DEVELOPMENT REVIEW BOARD - **HYDROLOGY SECTION**

DRB Project Number: 2021-006336 Hearing Date: **03-02-2022**

Project: **LOT 1, BLOCK 3 TOWN OF ATRISCO GRANT** zoned **NR-BP** Agenda Item No: **3**

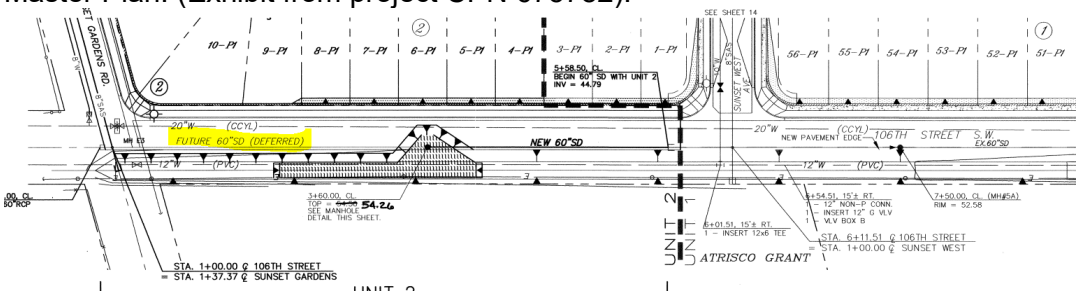
- Hydrology needs an approved Grading and Drainage Plan prior to approval of Site Plan for Building Permit.
  - Hydrology received the submittal on 12/4/2021 (L08D013). The submittal has been reviewed and comments given that must be addressed.
- Infrastructure List:
  - The site will be required to tie to the existing 60-inch storm drain along 106th St. south of Sunset Gardens. This will include the 60" storm drain shown below and additional infrastructure to include inlets and storm drain sized for the site and must follow the Amole Hubble Drainage Master Plan. (Exhibit from project CPN 675782).
  -
